Access Compliance Report

Public Rights-of-Way

Intersection ID: 46671	Main Street: DAMASK_DR	Cross Street: HUNSLET_CR	Location:	W
ADA ID: 7F5A33E9E2BE	Ramp Type: PerpDiag	Initial Pass/Fail: Fail	Overall Compliance: No	Severity Score: 25

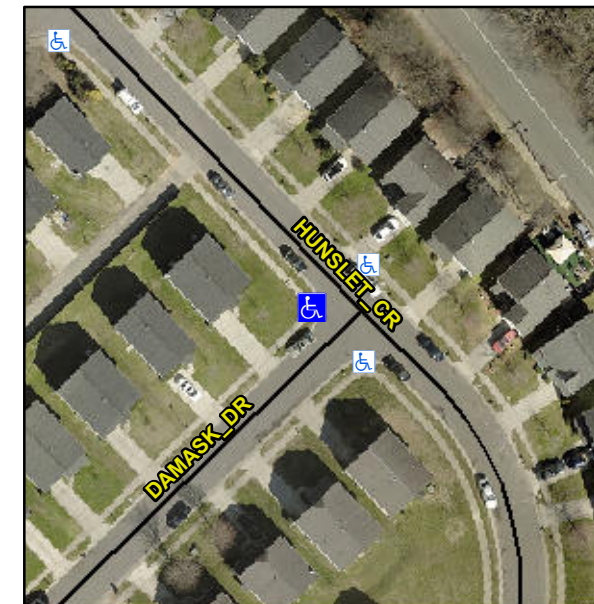
Not Found, R304.5.3

Compliance	Description	Data	Compliance	Description	Data
N/A	Ramp Length (in)	49.0	Yes	Ramp Slope (%)	5.3
Yes	Ramp Width (in)	48.0	No	Ramp XSlope (%)	8.0
N/A	Flare Type LT	N/A	N/A	Flare Type RT	N/A
N/A	Flare Slope LT (%)	N/A	N/A	Flare Slope RT (%)	N/A
N/A	Flare Traversable LT?	N/A	N/A	Flare Traversable RT?	N/A
N/A	Landing Length (in)	N/A	N/A	DWS Provided?	N/A
N/A	Landing Width (in)	N/A	N/A	DWS Contrast?	N/A
N/A	Landing Slope (%)	N/A	N/A	DWS Length (in)	N/A
N/A	Landing X Slope (%)	N/A	N/A	DWS Full Width?	N/A
N/A	Landing Curb? (Y/N)	N/A	N/A	DWS Offset (in)	N/A
N/A	Shared Landing?	N/A			
N/A	Gutter Ponding?	N/A	N/A	Gutter Slope (%)	N/A
N/A	Gutter Lip Ht (in)	N/A	N/A	Gutter X Slope (%)	N/A
N/A	Painted X Walk1?	No	N/A	Painted X Walk2?	No
	X Walk 1 Direction	To SE		X Walk 2 Direction	To NE
N/A	X Walk 1 Width (in)	N/A	N/A	X Walk 2 Width (in)	N/A
	X Walk 1 Slope (%)	1.4		X Walk 2 Slope (%)	3.3
	X Walk 1 X Slope (%)	4.2		X Walk 2 X Slope (%)	5.4

Remove & Replace Curb Ramp With Two New Directional Ramps or Equivalent.
